# AP1000 DCD SER Open Item REVIEW

OI Response Number: OI-SRP19.0-SPLA-12 Revision: 23

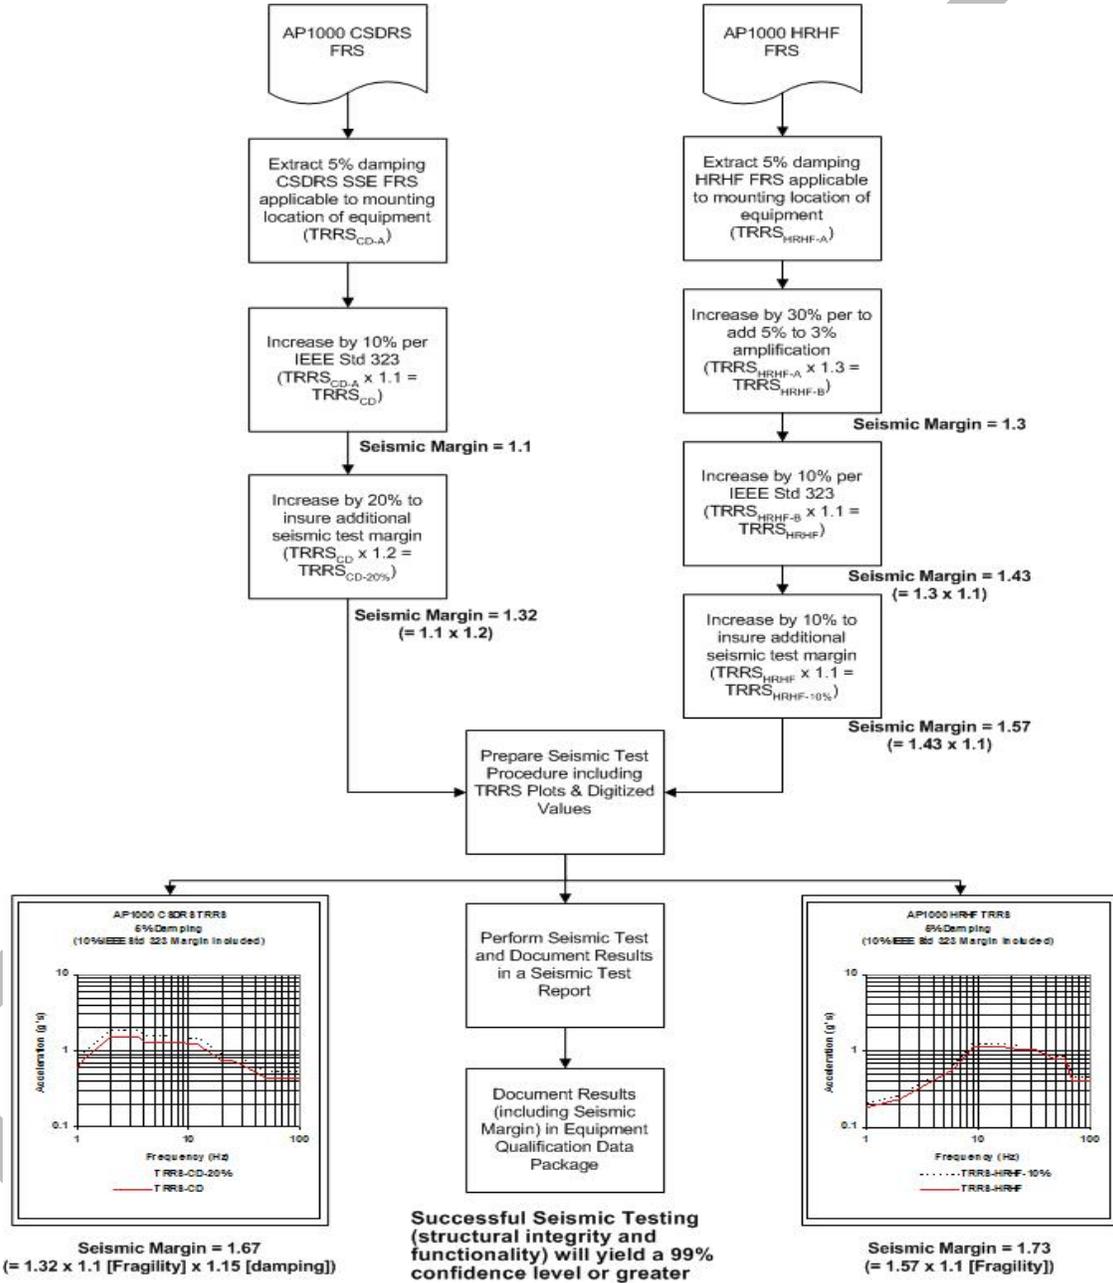
Confirm that an acceptable seismic margin is maintained for HRHF sites.

- a. Description of the seismic margin associated with seismic testing employing a 3% critical damping response spectra and tested/analyzed at 5% critical damping will be provided. Reference will be made to the technical criteria (WCAP or EPRI document) for changes amplification factors as a function of damping and the need for maintaining the peak to zero period acceleration (ZPA) ratio.
- b. An illustration will be provided to show the test required response spectra (TRRS) will include 10% margin . The illustration should indicate and clarify that 10% margin is not being "double counted."
- c. Illustrations will be provided to show the test response spectra (TRS) used to demonstrate acceptability envelope the TRRS with margin.
- d. Provide quantitative plots that are representative of the margins in testing.
- e. Describe the testing margin in the DCD.

Combining the seismic margin contributing factors for Design Basis HRHF sites noted above results in a seismic margin factor in the range of 1.73 to 1.97. An example of using the above seismic margin factors (except for the fifth bullet) is shown in Figures 1 and 2. The above seismic margin contributors (except for the first bullet) are also applicable to demonstrating the seismic capacity level of at least 1.67 for the CSDRS design basis. Therefore, based on the above there is sufficient seismic margin associated with the CSDRS qualification process and the HRHF screening for potential high frequency sensitive equipment to demonstrate compliance with the 1.67 factor recommended in References 2 and 3.

Determination and Documentation of Test Required Response Spectra for AP1000 Equipment Requiring Seismic Margin to meet NRC ISG DC/COL-ISG-020

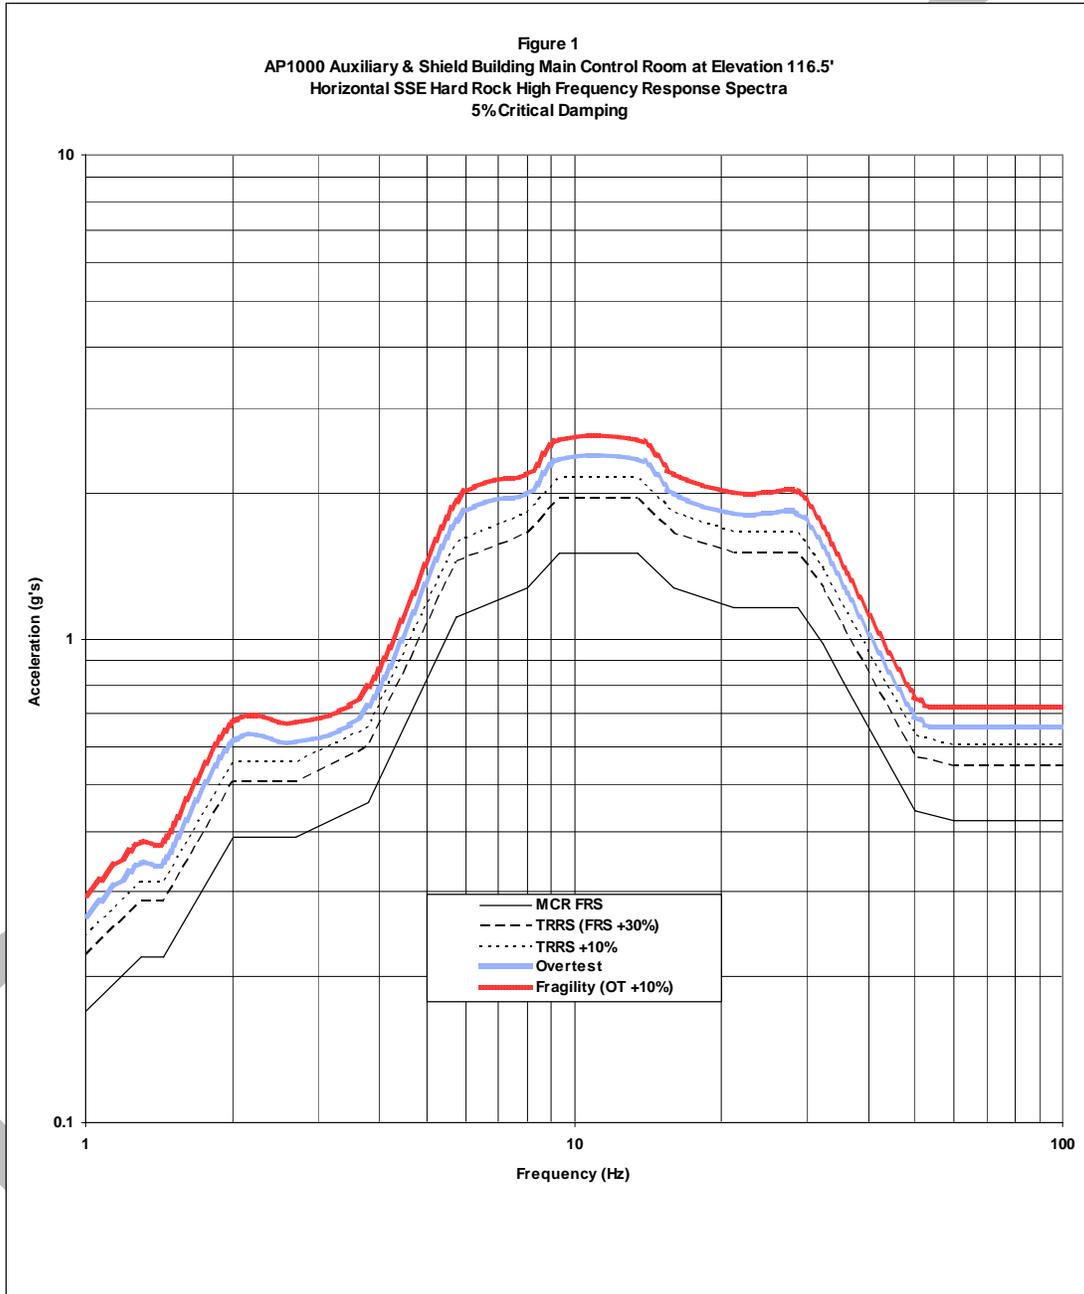
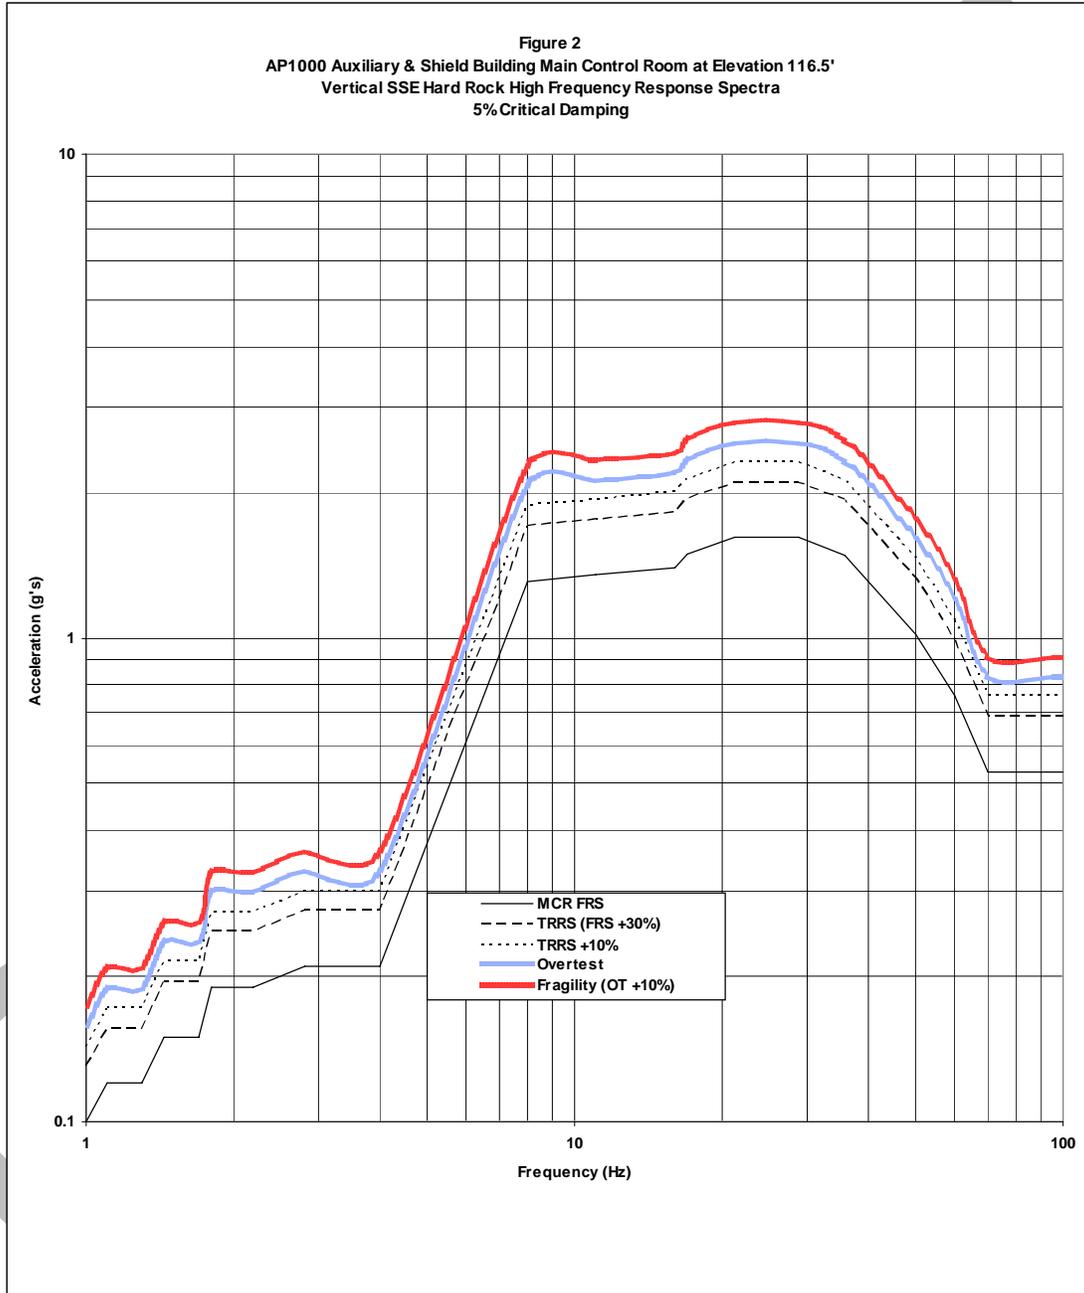
There is concern from the NRC staff that we are not going to be in full compliance with ISG-20 when it is issued in final form. The NRC has requested that we provide a documented process for how we will ensure that we maintain the 1.4 factor as defined in ISG-20.

Please see attachment A for the requested process for Seismic Margin verification in Seismic Testing. There are no DCD mark-ups specified in this revision but the track changes are being maintained to see what changes have been made to the DCD in Rev. 2.
